Townsville Ocean Terminal & Breakwater Cove

5002/02
R-KO0123- Rev 2
30 July 2008

Potential Operational Dredging Impacts on Water Quality

DEWATERING FACILITY

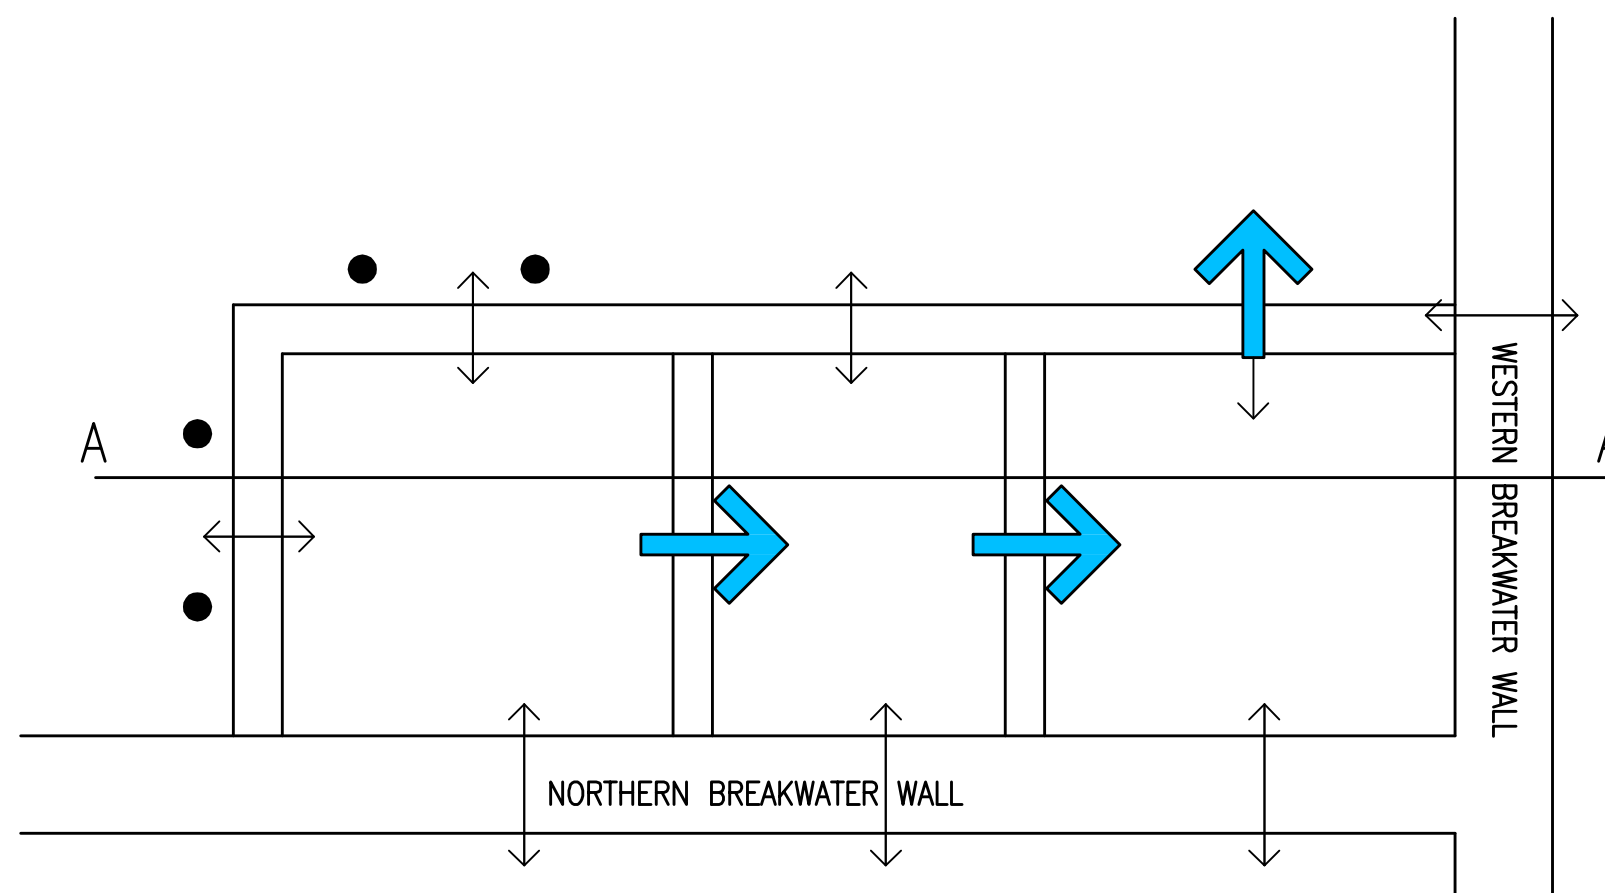
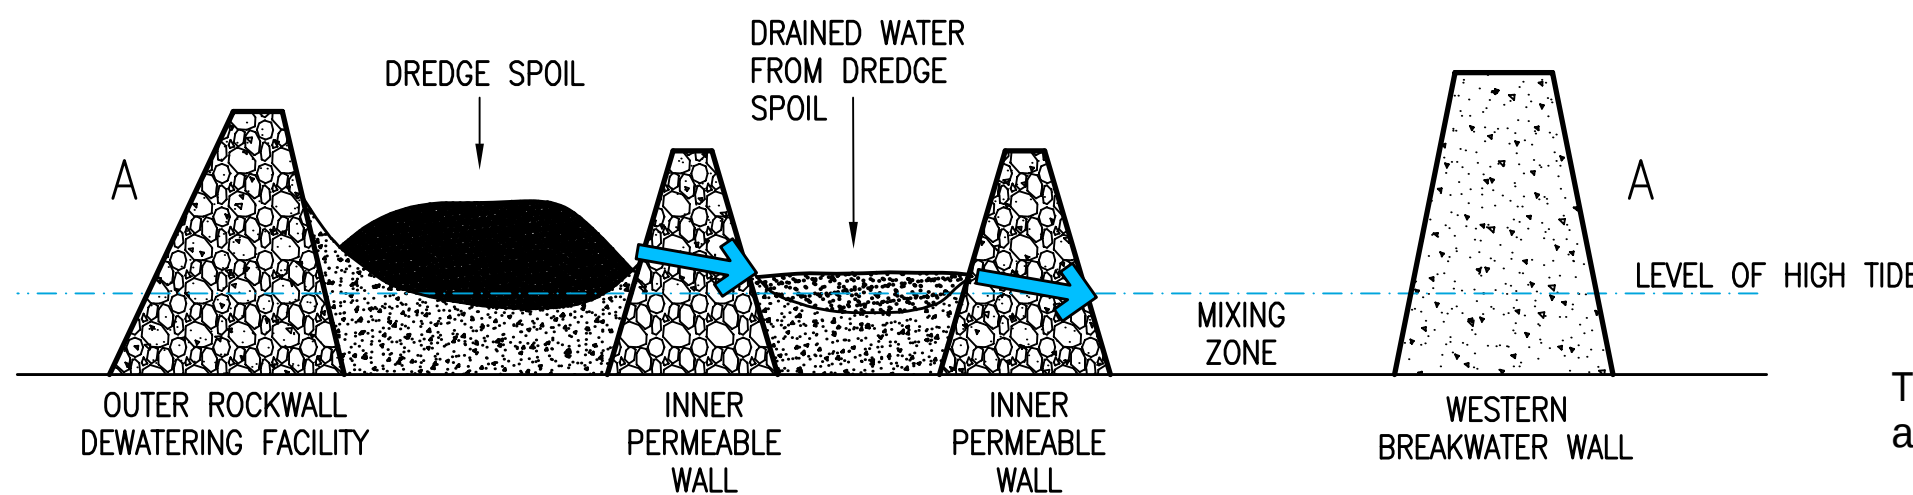
A dewatering facility for operational purposes is proposed to be established at the north-eastern end of the development, adjacent to the marina entrance (refer **Figure 1 and Figure 2**). This facility may not be needed for 12 years or more due to the sump capacity within Breakwater Cove. Dredged material placed in the facility will dewater via gravity and then subject to compliance testing, disposed to Stuart Landfill or an alternative reclamation facility/reuse. The disposal criteria for Stuart Landfill is presented in **Appendix A**. Based on site activities it is highly unlikely material (post dewatering and drying) would not be suitable for disposal to Stuart Landfill,. The following will need to be considered as part of the detailed design and operational works approval:

- The dewatering facility will need to be segregated so that drained water can be isolated from dredge spoil and tested prior to discharge to marine environment via a diffuse mechanism;
- Water quality will need to meet the water quality criteria, which will be agreed in consultation with the EPA;
- Fencing or an alternative barrier will need to be installed to provide a barrier to public access to the dewatering facility;
- Proposed dewatering pond has a proposed area of approximately 10,000 m². With an assumed height of 2m above water level this equates to

a holding capacity of 20,000m³. This will enable the operational dredging to be carried out on a 2-3year cycle.

On site dewatering will require the use of a clam shell dredge to keep total dredge volume below 20,000m³. The water would be progressively discharged, after compliance testing, during the dewatering process.
